Subject: Subject: Concerns Regarding Privacy Impact and Proposed Modifications for Carlingford West Public School and Cumberland High School (SSD-43065987-MOD-2)

Photo 3 No.9's backyard, overlooking directly to Building W's windows.

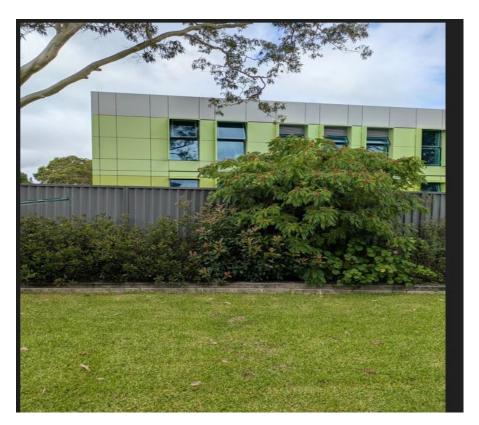
In addition, as per the existing trees in front of building W, please refer to the photos. we are still able to overlook each other which disturbs both privacies.

Photo 4 Half frosted windows as shown in the above picture.

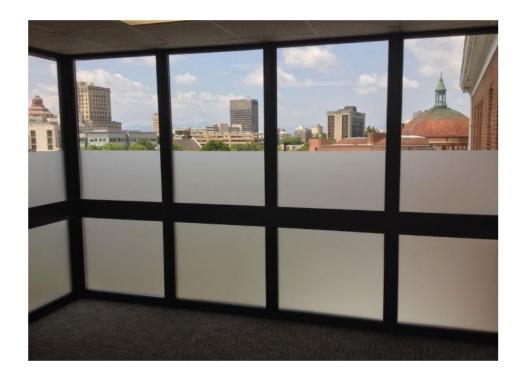
- 1. **Frosted Windows:** Install frosted windows up to 1800mm in height, as illustrated below, to ensure privacy without obstructing natural light. This solution would provide an immediate and permanent resolution.
- 2. **Evergreen Planting:** Plant evergreen, low-maintenance, narrow, tall-growing conifers along the fence line instead of shrubs to create a more effective and lasting privacy barrier.
